October 21, 2022  
L-22-200

Subject:  
Beaver Valley Power Station, Unit No. 2  
Docket No. 50-412, License No. NPF-73  
Response to Request for Additional Information Regarding a 180-Day Steam Generator  
Tube Inspection Report – Fall 2021 Refueling Outage (EPID No. L-2022-LRO-0064)

**Beaver Valley Power Station, Unit 2 - Responses to Request For Additional Information -  
Refueling Outage 22 Steam Generator 180 Day Report**

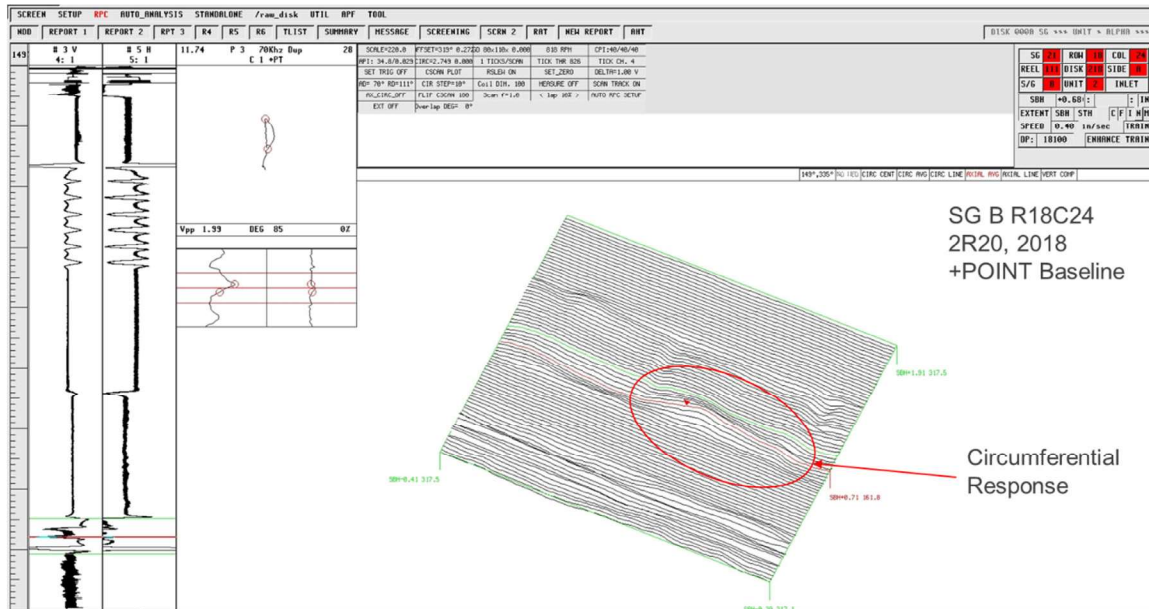
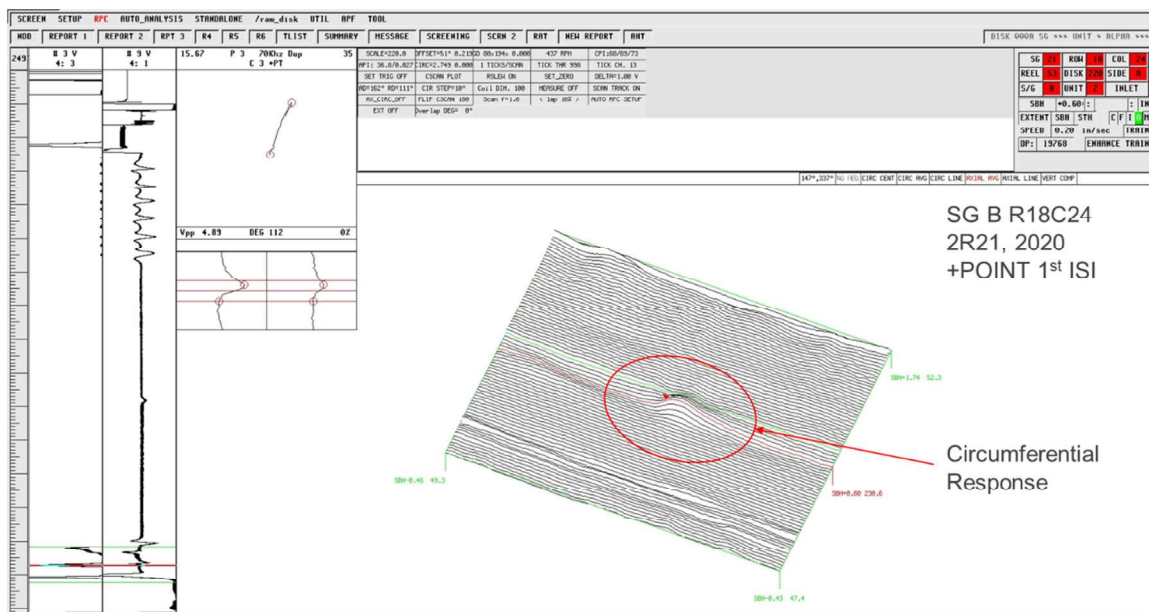
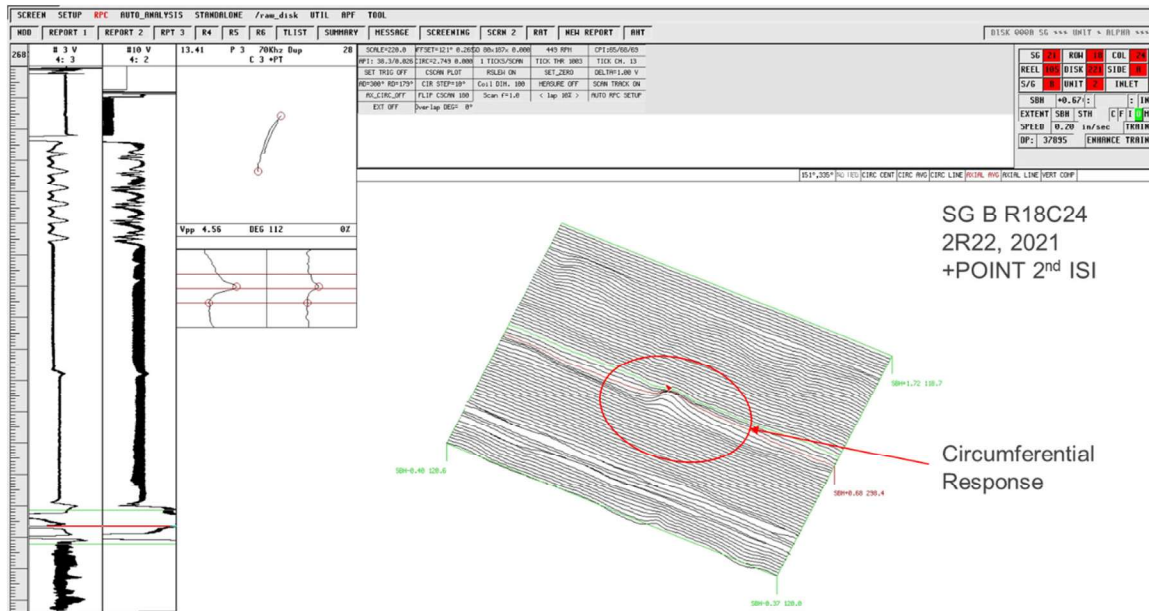
During 2R22, the +Point™ probe observed circumferential indications in four Alloy 800 nickel banded mechanical tubesheet sleeves (three installed in 2R20 (2018) and one installed in 2R21 (2020)) located at the lower tubesheet hard roll joint at the lower expansion transition below the nickel band region. It was noted that one of the sleeves installed in 2R20 (2018) had a circumferential signal after sleeve installation and prior to being placed in service. While preliminary assessments suggested the signals could be circumferential outside diameter stress corrosion cracking (ODSCC) on the outer surface of the parent tube, it was determined that the circumferential signals may be fabrication related and not flaws because (1) flaws at this location are not likely due to the full-depth hard roll condition of the parent tube, (2) one circumferential signal had a precursor after sleeve installation and prior to being placed in service, and (3) the Ghent Version 2 probe did not observe signals like those observed by the +Point™ probe and did not detect any flaw-like signals. The affected tubes were proactively plugged during 2R22. Please discuss the following:

- a. A comparison of the precursor eddy current signal in the one sleeve installed in 2R20 (2018) compared to the circumferential signal observed during 2R22.

The nickel banded mechanical tubesheet sleeve in SG B Tube R18C24 was installed in 2R20 (2018). The baseline sleeve inspection was performed with the +POINT probe only, as the Ghent Version 2 probe had not been developed at the time of the inspection. A circumferential signal was present below the nickel band region from historical data review of the baseline +POINT probe inspection as shown in Figure 1. During the subsequent in-service inspections (ISI) of this sleeve performed in 2R21 (2020) and 2R22 (2021), the combination Ghent Version 2 probe was used for the inspection of sleeves.

The combination Ghent Version 2 probe contained both magnetically biased Ghent coils and +POINT coils. The +POINT coil response of the circumferential signal changed from 2R20 to 2R21 as shown by comparing the probe responses in Figure 1 and Figure 2. The change in the +POINT probe signal response from the 2R20 baseline inspection is attributed to the strong magnet contained in the Ghent portion of the probe. The strong magnet in the Ghent V2 probe magnetizes the sleeve/parent tube which is detected by the +Point coil prior to the test piece magnetization dissipating. This magnetic saturation decreases permeability variations within the sleeve/parent tube which in turn improves eddy current flow through the test piece, ultimately providing improved detection capability for the +Point coil. The +POINT response did not change from 2R21 to 2R22 as shown in Figure 2 and Figure 3 when both inspections used the combination Ghent Version 2 probe.
